RE: ADDENDUM No. **3 (THREE)** to the Bidding Documents for:
AMHI Potting Shed Conversion, Augusta, ME 04333

This ADDENDUM forms a part of the Contract Documents and modifies the original Bidding Documents dated 12/22/2015. Acknowledge receipt of this ADDENDUM in the space provided on the Proposal Form. Failure to do so may subject Bidder to disqualification.

This ADDENDUM consists of (5) Five pages and (7) Seven Sketches and revised Table of content

SKS-01
 ADDENDUM #3

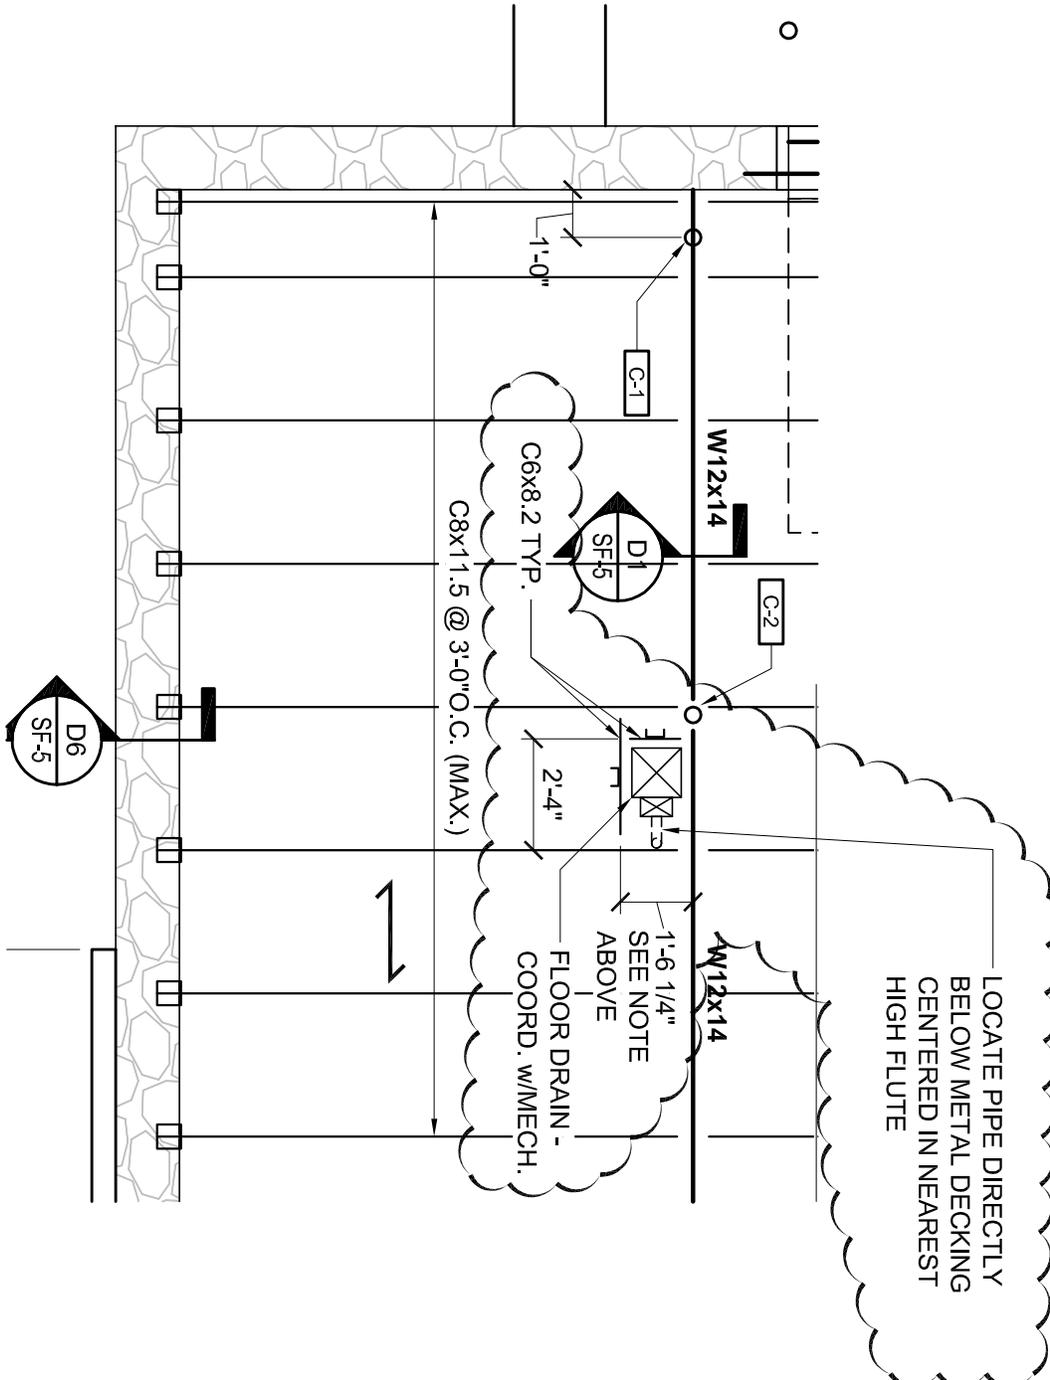
1. **ADD** SKS-01 ADDED DETAIL D8.

ADDED DETAIL D8/SF-5

SKS-02 ADDENDUM #3	REVISION TO E1/SF-1 FIRST FLOOR FRAMING (PARTIAL PLAN)	
	AMHI - POTTING SHED CONVERSION FOR BUREAU OF GENERAL SERVICES	
	SCALE: NTS	PROJ NO: 15056
	DATE: 01/14/2016	CAD FILE: 15056S.dwg

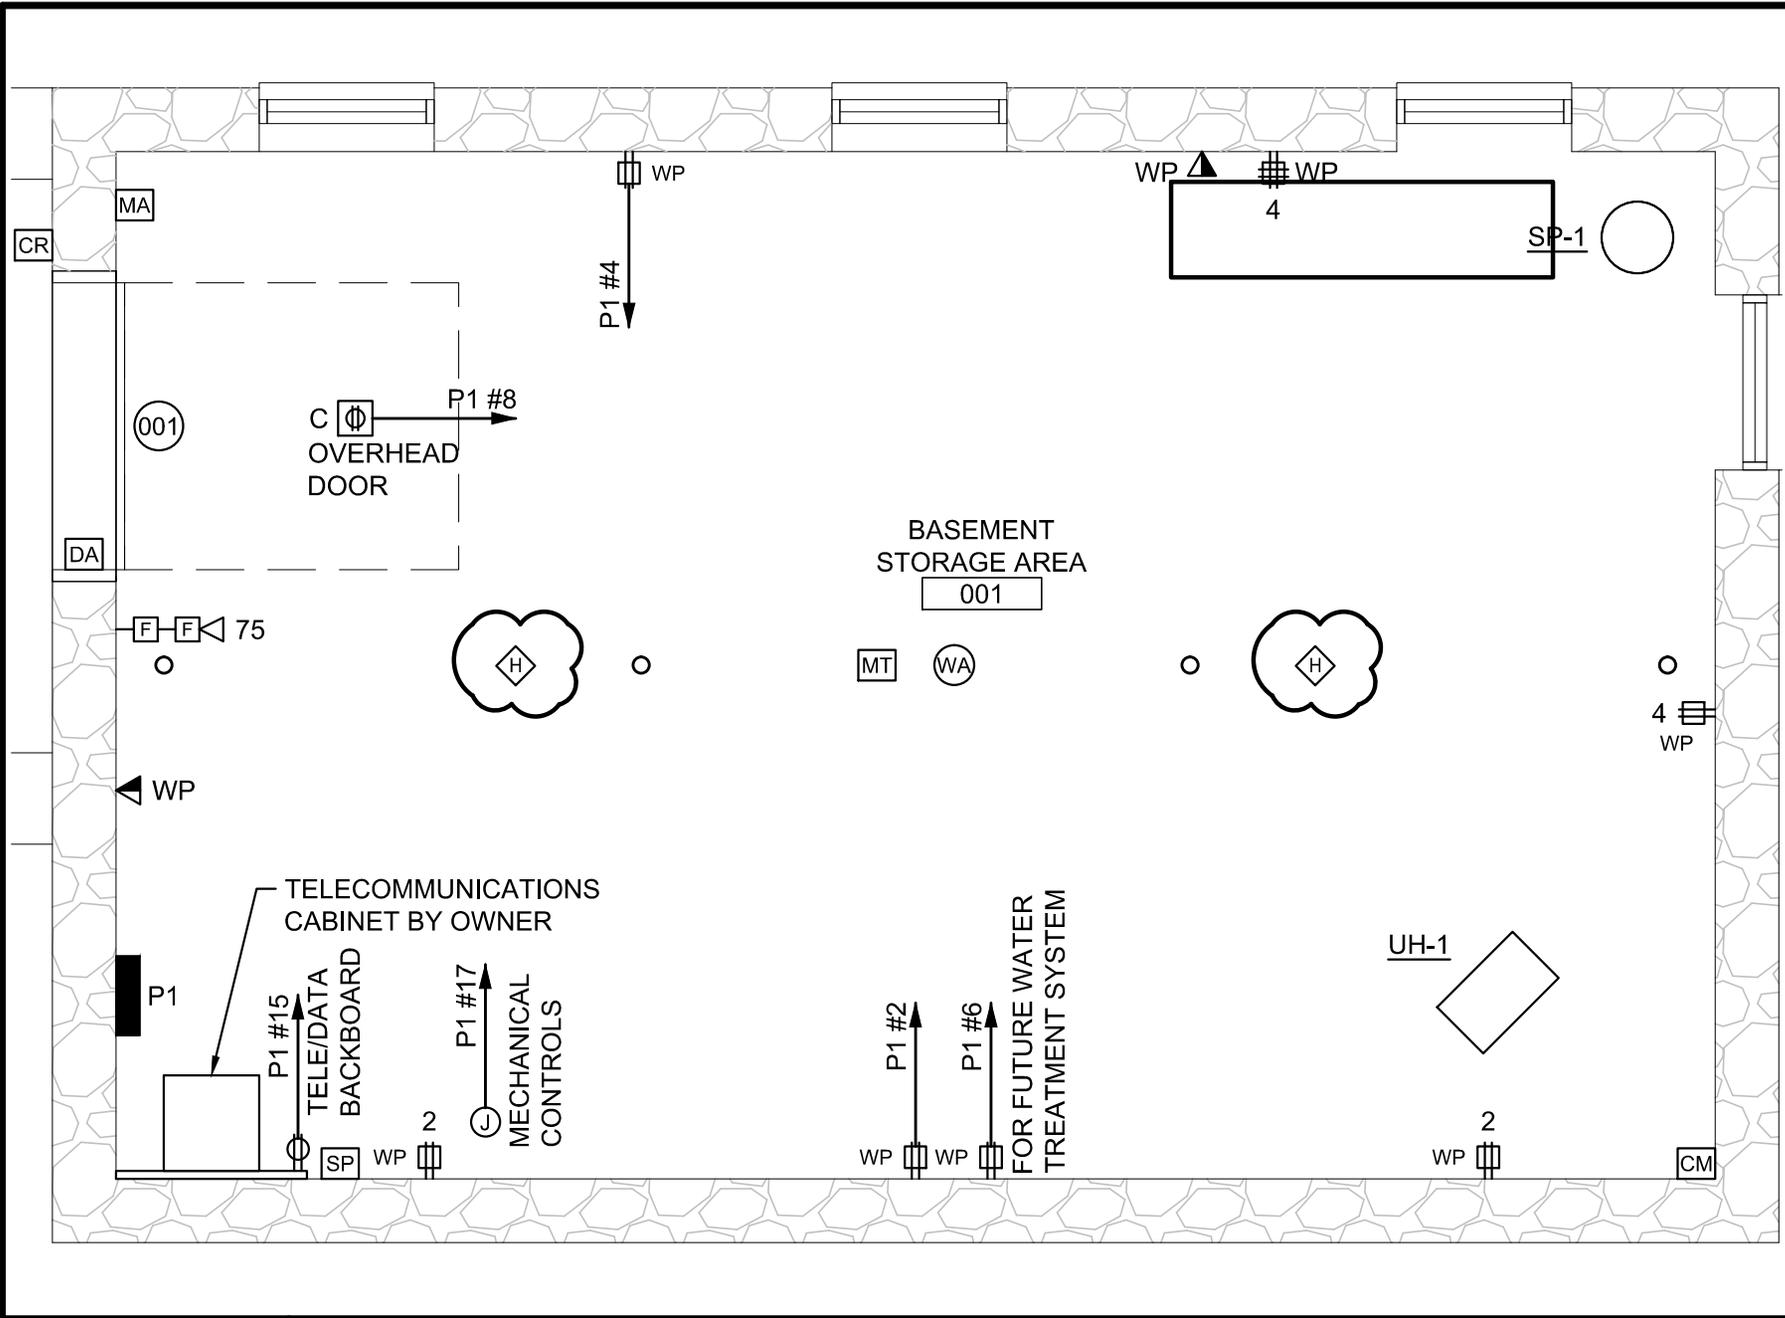
1. DETAIL E1
 - a **DELETE** Dimension at right corner of the entrance ramp 6"
 - b **ADD** in its place 5"
 - c **ADD** SKS-02 for framing detail at FD1 (Floor Drain)

SKE-01
 ADDENDUM #3

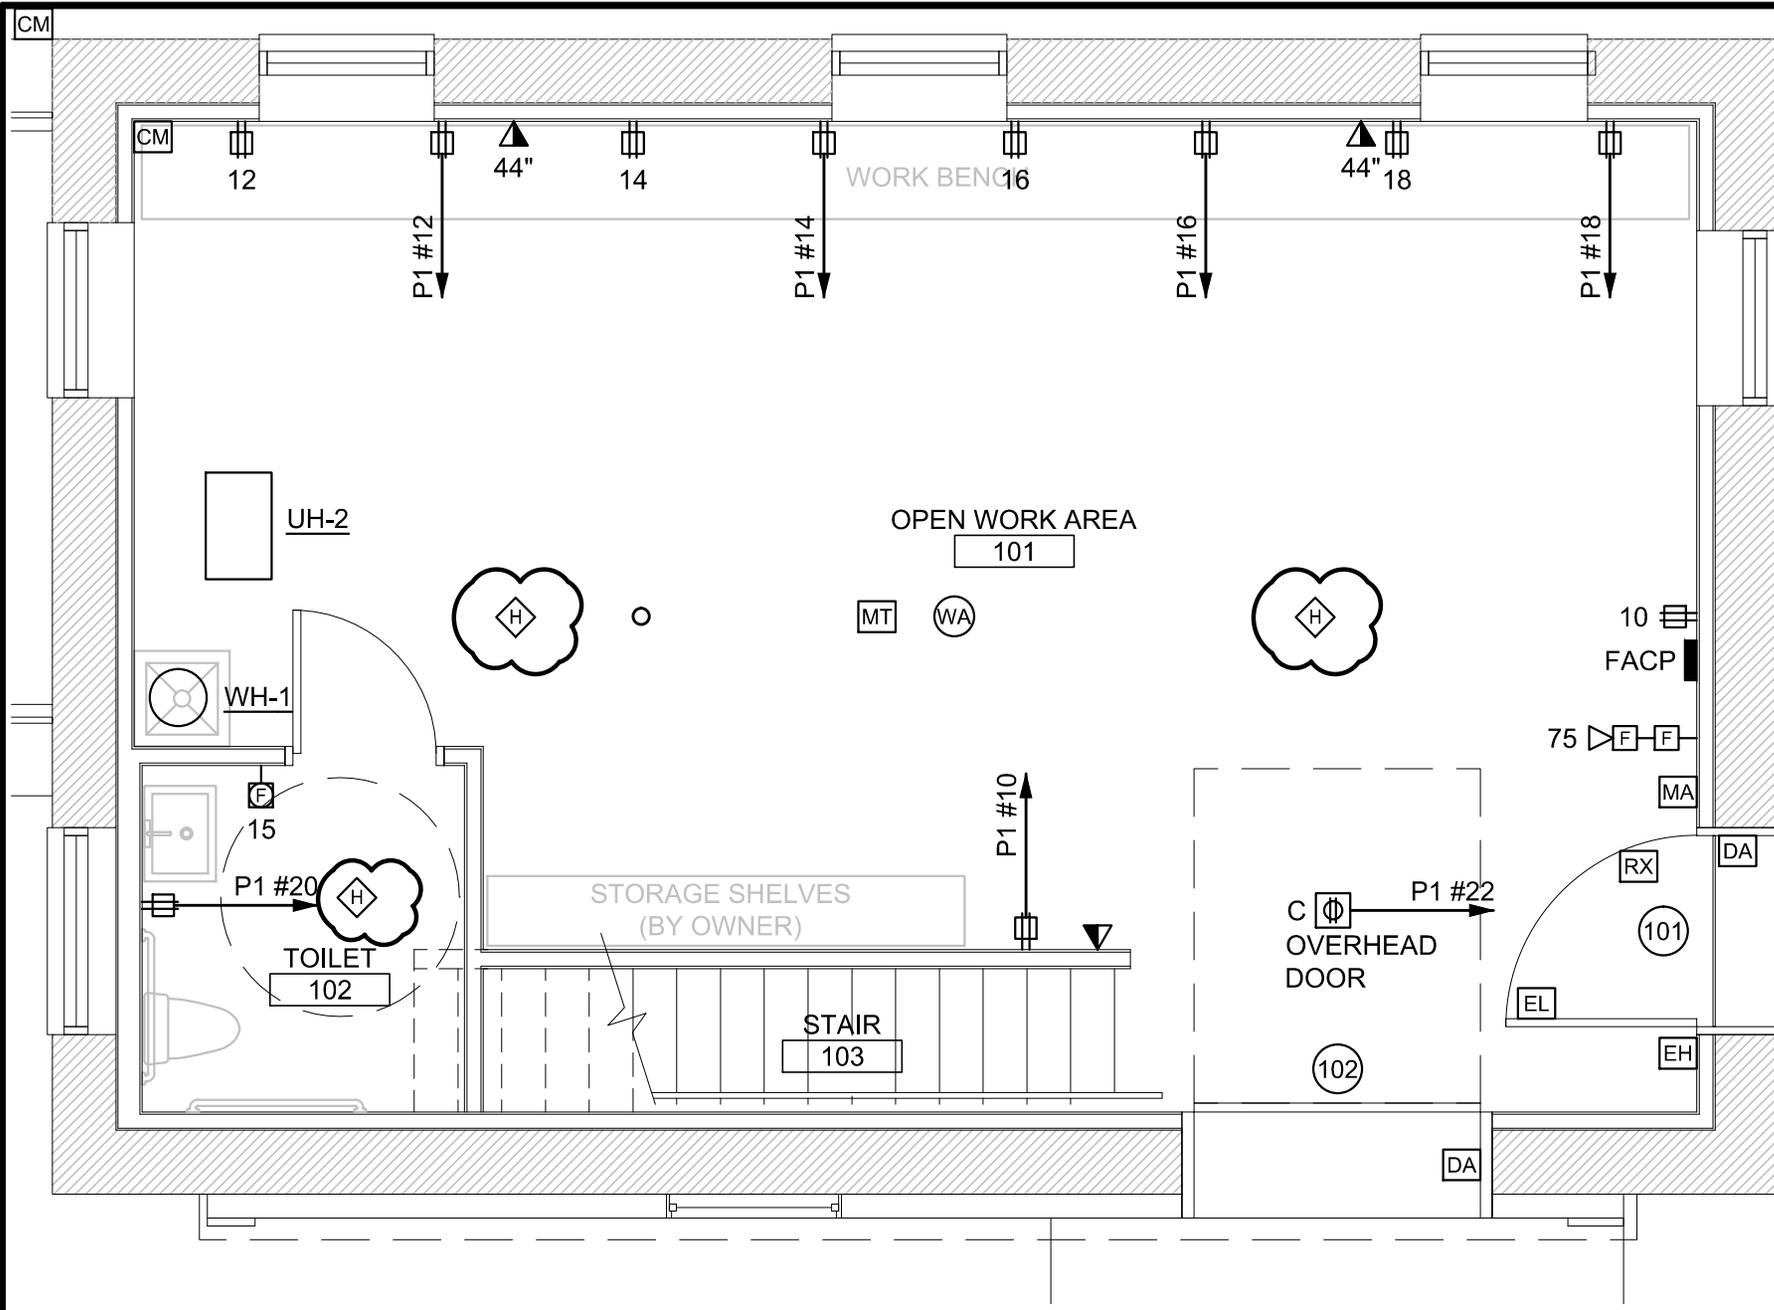
- a Refer to attached sketches SKE-01, SKE-02, and SKE-03 for revisions.

- a. If yes, one detector (suggestion heat) will need to be installed above the fire panel to meet code requirements. **ANSWER: Heat detector will be required. Sketches will be included in ADDENDUM #3.**

BASEMENT HEAT DETECTORS - SEE DWG. EP-1	
AMHI - POTTING SHED CONVERSION FOR BUREAU OF GENERAL SERVICES	
SCALE: NOTED	PROJ NO: 15056
DATE: 1/14/2016	CAD FILE: 15056E.dwg

SKE-03

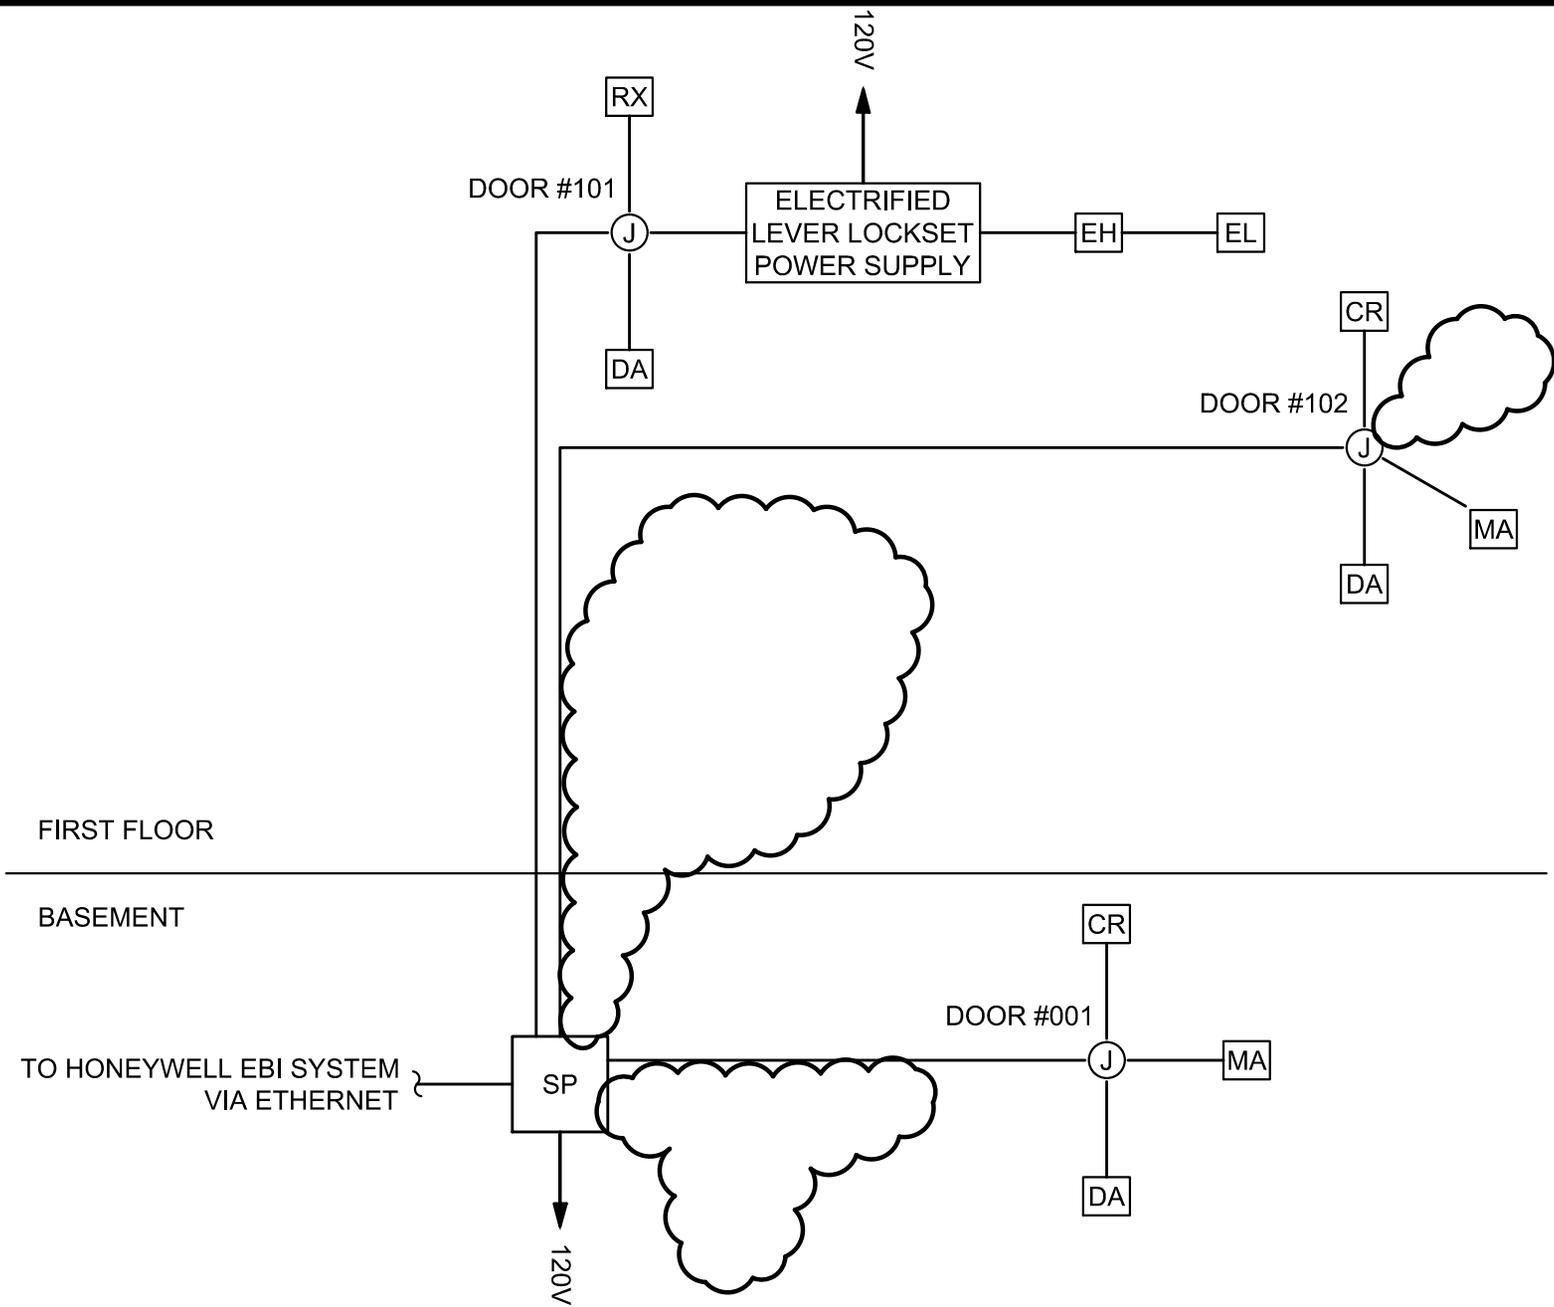
7. Will this building be sprinkled? **ANSWER: Not required**
8. Code requires a pull station at the exit of a floor, so an additional pull will be located by stairs on 2nd floor. **ANSWER: A sketch to add the pull station will be included in ADDENDUM #3.**

ATTIC HEAT DETECTORS AND PULL STATION -
 SEE DWG. EP-1
